PROPOSED RESIDENTIAL DEVELOPMENT ON LAND SOUTH OF THE
B6022 NEWARK ROAD, SUTTON IN ASHFIELD, NOTTINGHAMSHIRE

RESPONSE REPORT TO
STAGE 1 ROAD SAFETY AUDIT
ON COMPLETE PRELIMINARY DESIGN OF MITIGATION PACKAGE

STAGE 1 ROAD SAFETY AUDIT REPORT

Stage 1 - Completion of Preliminary Design

ADC1580-003-P10

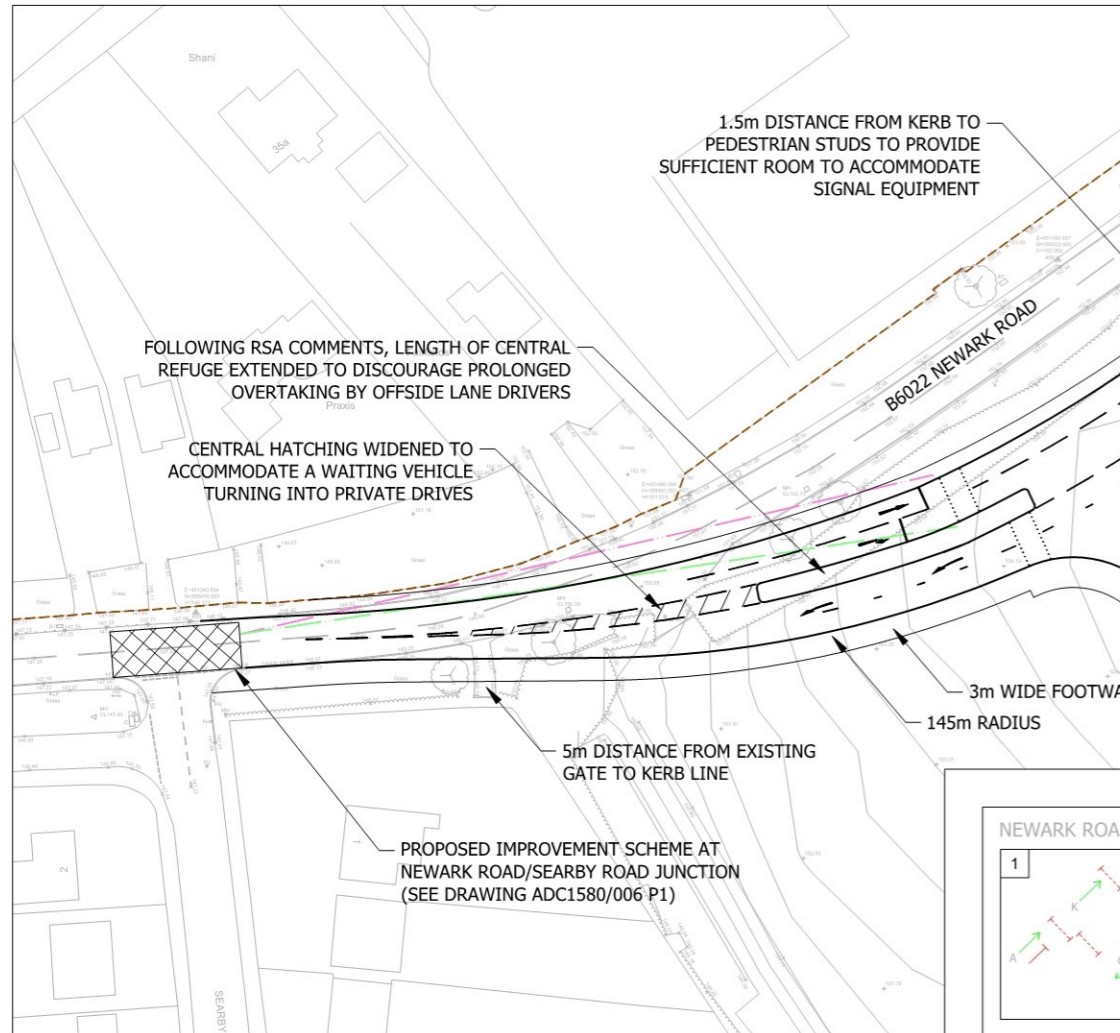
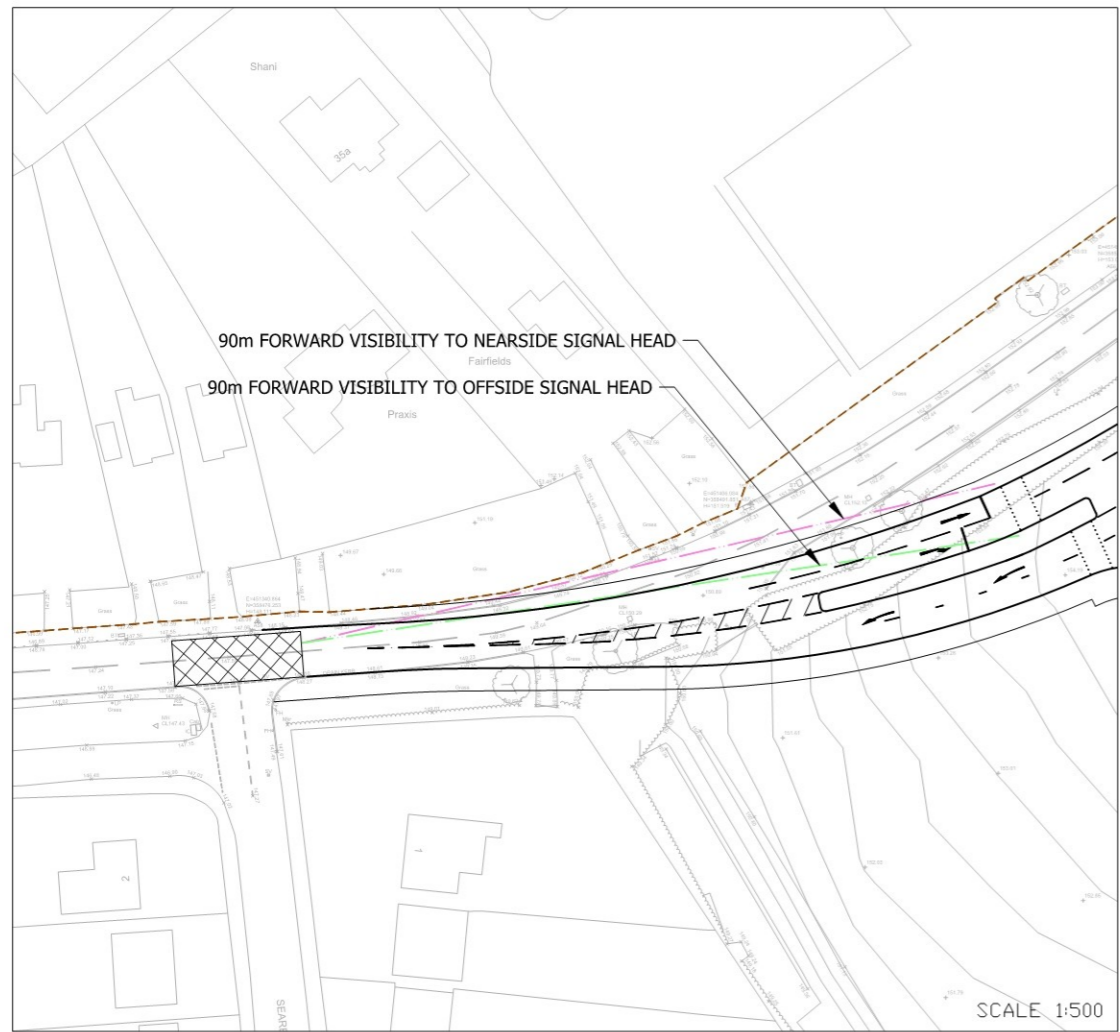
In Stage 3 of the Traffic Signal operation, right turning drivers onto Newark Road from the development arm appear to run into a red light as they are about to exit the junction, presumably to allow pedestrians to cross this exit. However this arrangement is uncommon, and most drivers when turning right will be expecting to exit the junction unimpeded. Due to their angle of approach to the signal heads they will get very little warning of the unusual layout. Drivers who do manage to spot the signals will reasonably assume that they are looking at red secondary aspects for eastbound Newark Road traffic, which is currently held to allow the right turners to emerge. According to the phasing diagram, at this point pedestrians will cross this eastbound exit, since they are presented with a Green Man. They will be at significant risk of being struck by right turning vehicles, whose drivers have unwittingly contravened the red signals, causing potentially serious injuries. Alternatively, a driver who manages to stop may be shunted by a following right turning driver, who having just entered the junction on a green light will not expect to have to brake so soon.

There are a small number of private residential properties to the west of the traffic signal junction, on the north side of Newark Road. This may present two problems. Firstly, drivers waiting to turn right into these accesses will have to wait in the westbound exit close to the junction. At this point there are two lanes merging together, and westbound main road drivers will be concentrating on adjacent or following vehicles as they attempt to merge/overtake. Additionally, they will not anticipate that a vehicle may stop at this point, since the houses are well set back from the road. Waiting stationary right

Related to the above, the layout of the exit merge for west bound traffic may encourage traffic in the offside lane to delay their merge in order to overtake nearside vehicles, by overrunning the central hatching, and entering the opposing traffic stream if it appears clear. This will result in late forced merging, or even head on collisions with opposing traffic. It will also exacerbate the situations described in 3.2.2 above

Drawing ADC1580-003-P10 shows the latest stage arrangement. In summary, for a large amount of the time the junction will operate three stages with both Newark Road ahead traffic in Stage 1, Newark Road eastbound and right turn traffic into the development in Stage 2 and the development traffic in Stage 3. Pedestrian phases are integrated into the first three stages except for the exit crossing on Newark Road. When this crossing is called, Stage 4 is called that gives a green signal to westbound traffic on Newark Road, allowing pedestrians to cross the approach arms of Newark Road eastbound and the site access, as well as the exit crossing on Newark Road.

Agreed. Drawing ADC1580-003-P10 provides wider central hatching to allow private cars to wait in whilst trying to negotiate a right turn into the private drives.

Agreed. Drawing ADC1580-003-P10 includes an extended central refuge to discourage prolonged overtaking by offside lane drivers. The central refuge has been cut short to allow a car to turn into the central hatching whilst waiting to turn right into the private drives.

Drg No: ADC1580/003
Rev: P10

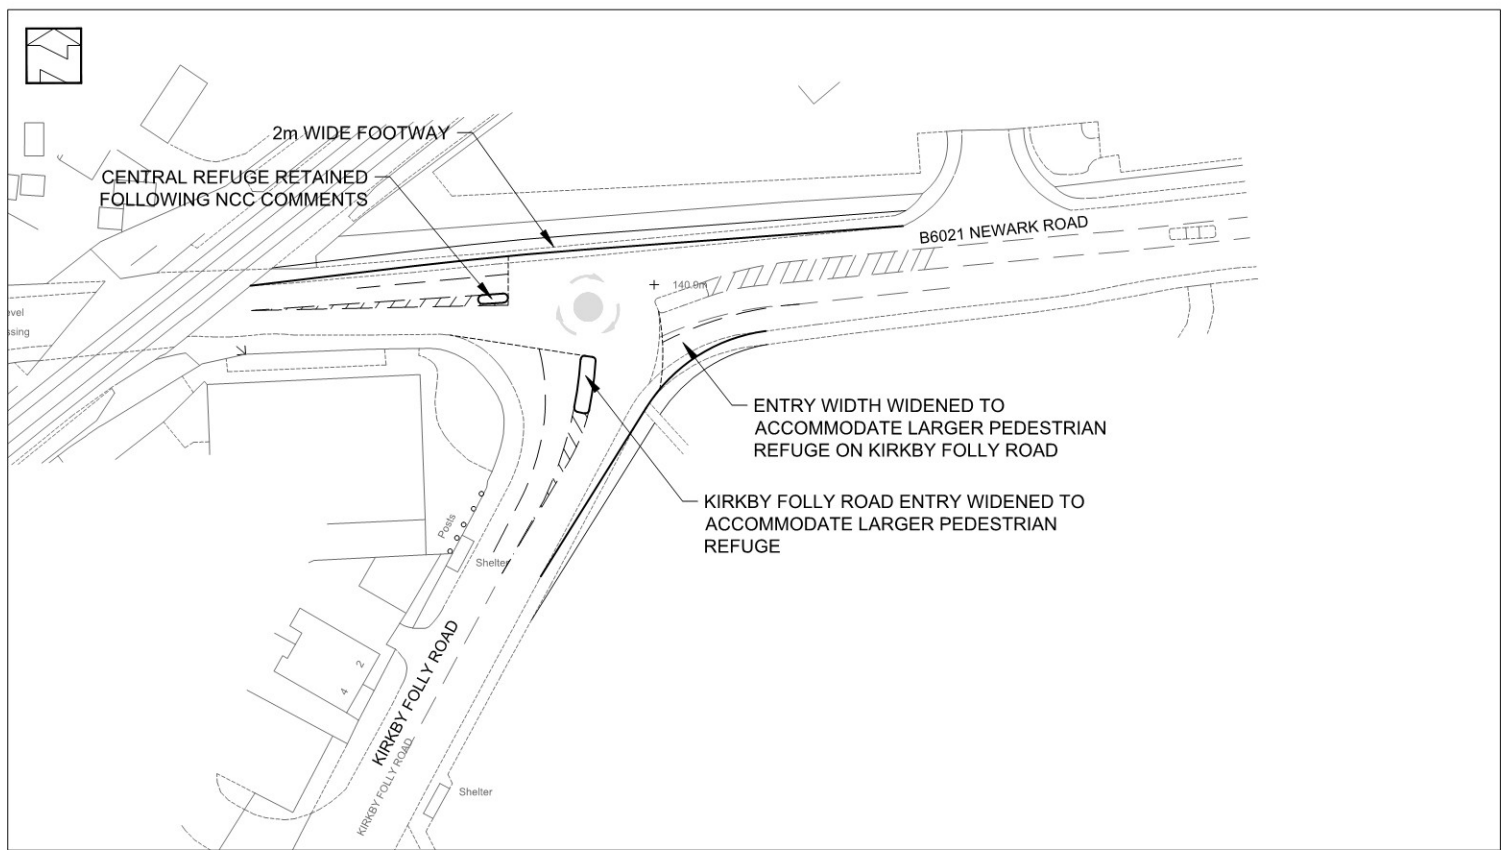
In Stage 3 of the Traffic Signal operation, right turning drivers onto Newark Road from the development arm appear to run into a red light as they are about to exit the junction, presumably to allow pedestrians to cross this exit. However this arrangement is uncommon, and most drivers when turning right will be expecting to exit the junction unimpeded. Due to their angle of approach to the signal heads they will get very little warning of the unusual layout. Drivers who do manage to spot the signals will reasonably assume that they are looking at red secondary aspects for eastbound Newark Road traffic, which is currently held to allow the right turners to emerge. According to the phasing diagram, at this point pedestrians will cross this eastbound exit, since they are presented with a Green Man. They will be at significant risk of being struck by right turning vehicles, whose drivers have unwittingly contravened the red signals, causing potentially serious injuries. Alternatively, a driver who manages to stop may be shunted by a following right turning driver, who having just entered the junction on a green light will not expect to have to brake so soon.

There are a small number of private residential properties to the west of the traffic signal junction, on the north side of Newark Road. This may present two problems. Firstly, drivers waiting to turn right into these accesses will have to wait in the westbound exit close to the junction. At this point there are two lanes merging together, and westbound main road drivers will be concentrating on adjacent or following vehicles as they attempt to merge/overtake. Additionally, they will not anticipate that a vehicle may stop at this point, since the houses are well set back from the road. Waiting stationary right turners are likely to be shunted at speed, resulting in potentially serious injuries to vehicle occupants and riders.

Related to the above, the layout of the exit merge for west bound traffic may encourage traffic in the offside lane to delay their merge in order to overtake nearside vehicles, by overrunning the central hatching, and entering the opposing traffic stream if it appears clear. This will result in late forced merging, or even head on collisions with opposing traffic. It will also exacerbate the situations described in 3.2.2 above

Status at this Stage 1 Road Safety Audit – Closed: The current drawing ADC1580/003/P11 indicates that Stage 3 now facilitates right turning traffic from Phase C, that is not subsequently stopped at Phase J. The audit team have no further comments on this at this stage.

Status at this Stage 1 Road Safety Audit – Closed: In principle this problem appears to have been addressed. However, this particular item will require further consideration at the next stage of Road Safety Audit when the carriageway markings have been detail designed, especially in terms of the width of the central hatched ghost island area.

Status at this Stage 1 Road Safety Audit – Closed: In principle this problem appears to have been addressed. However, this particular item will require further consideration at the next stage of Road Safety Audit when the traffic signs and carriageway markings have been detail designed, especially in terms of get over arrow markings and warning signs to indicate lane drop or similar.

ADC INFRASTRUCTURE		
Org Size:	Scale:	Date:
A3	1:500	17/07/2017
Org No:	Rev:	
ADC1580/005	P7

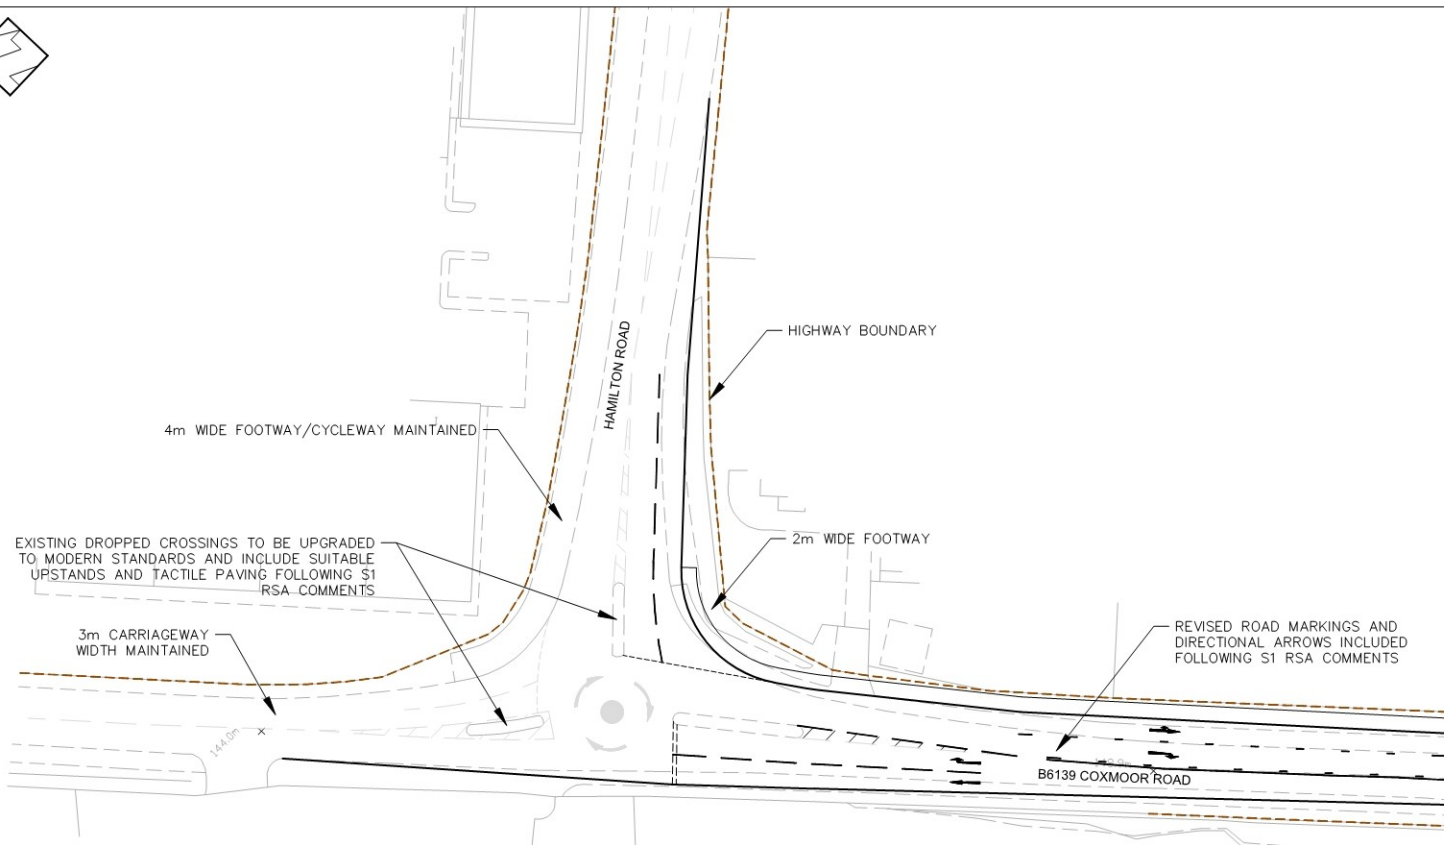
On the section of Coxmoor Road to the southeast of the Hamilton Road mini-roundabout, the revised layout includes widening and additional lanes. This is to accommodate increased queuing traffic at both the Hamilton Road and Cauldwell Road junctions. At one point there are two lanes shown in each direction, i.e. four lanes in all. Drivers may become confused about the direction and allocation of lanes here and this may result in incorrect lane usage. This may lead to a variety of conflicts, including head-on collisions, sudden lane changes and shunt type accidents. Any of these could lead to injuries to vehicle occupant and riders.

Ensure that the thermoplastic markings offer clear guidance to road users as to the direction and designation of each traffic lane. A strengthened centre line is recommended to segregate opposing traffic, and a generous provision of directional lane arrows should be employed to illustrate the intended directions of flow. Where lanes are developed or dropped, care should be taken to ensure that road users are not inadvertently guided into opposing traffic or incorrect lanes. Situations of poor conspicuity, e.g. at night or when the road is wet, should be taken into consideration.

Ref	Audit Comments	Response
2.6	<p>Location: B6139 Coxmoor Road southeast of the Hamilton Road mini-roundabout.</p> <p>PROBLEM:</p> <p>On the section of Coxmoor Road to the southeast of the Hamilton Road mini-roundabout, the revised layout includes widening and additional lanes. This is to accommodate the increased queuing traffic at both the Hamilton Road and Cauldwell Road junctions. At one point there are two lanes shown in each direction, i.e. four lanes in all. Drivers may become confused about the direction and allocation of lanes here and this may result in incorrect lane usage. This may lead to a variety of conflicts, including head on collisions, sudden lane changes and shunt type accidents. Any of these could lead to injuries to vehicle occupants and riders.</p> <p>RECOMMENDATION:</p> <p>Ensure that the thermoplastic markings offer clear guidance to road users as to the direction and designation of each traffic lane. A strengthened centre line is recommended to segregate opposing traffic, and a generous provision of directional lane arrows should be employed to illustrate the intended direction of flow. Where lanes are developed or dropped, care should be taken to ensure that road users are not inadvertently guided into opposing traffic or incorrect lanes. Situations of poor conspicuity, e.g. at night or when the road is wet, should be taken into consideration.</p>	<p>Agreed.</p> <p>Road markings to be confirmed during detailed design.</p> <p>Nevertheless, Drawing ADC1580-005-P7 presents revisions to the road markings between the Hamilton Road mini-roundabout and the Coxmoor Road/Newark Road signal junction.</p>
